UNITED STATES PATENT AND TRADEMARK OFFICE

APPLICATION NO.	FILING DATE	FIRST NAMED INVENTOR	ATTORNEY DOCKET NO.	CONFIRMATION NO.
10/826,328	04/19/2004	Kuo-Yen Lai	Lai- 9308	9481
7590 11/01/2005				
HungChang Lin 8 Schindler Ct. Silver Spring, MD 20903			EXAMINER DZIERZYNSKI, EVAN P	
			ART UNIT 2875	PAPER NUMBER

Office Action Summary

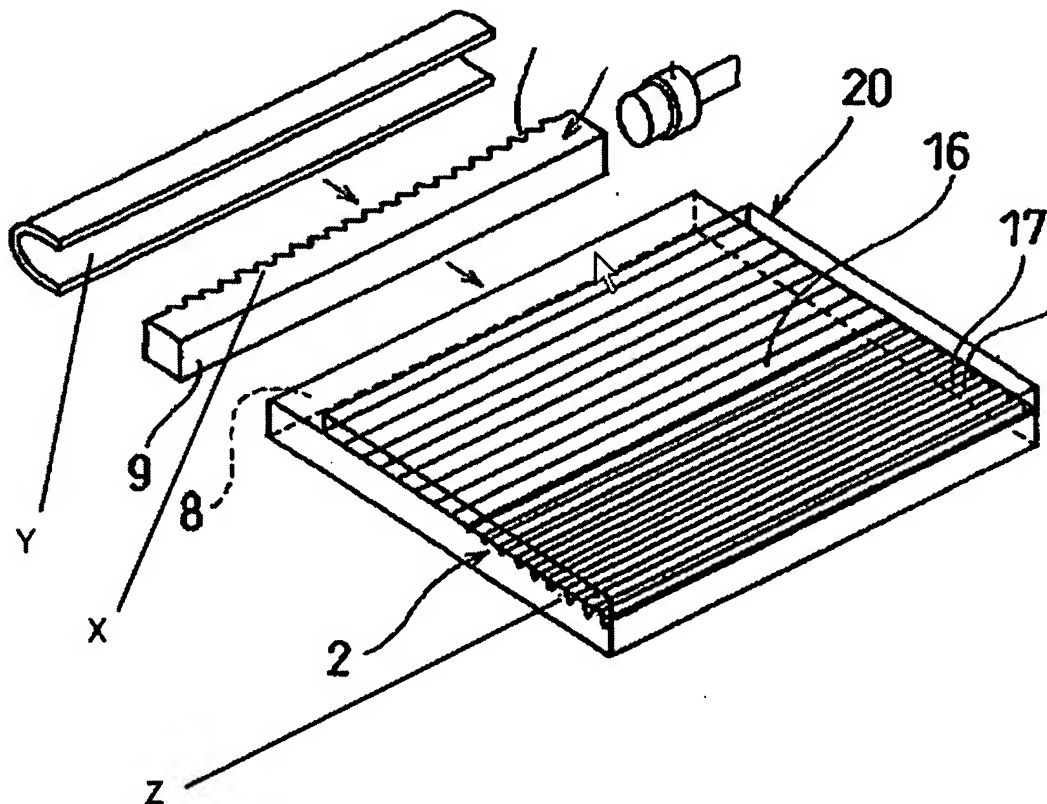
Asakawa et al. teaches backlight system for a display panel comprising a point light source 4, a first light reflecting unit 12,13 to reflect and to spread the incident light beam from the light source in a first direction, and a second light reflecting unit 16 to spread the reflected light from the first light reflecting unit in a second direction and to

project the reflected light from the second light reflecting unit onto a display screen 10 as a backlight

As for claim 2, Asakawa further teaches the first light reflecting unit having a ladder planar contour (indicated below as X) and a curved surface contour reflecting surface (indicated below as Y).

As for claim 3, Asakawa further teaches the second reflecting unit having a Ladder convex contour sloped reflecting surface (indicated above as Z).
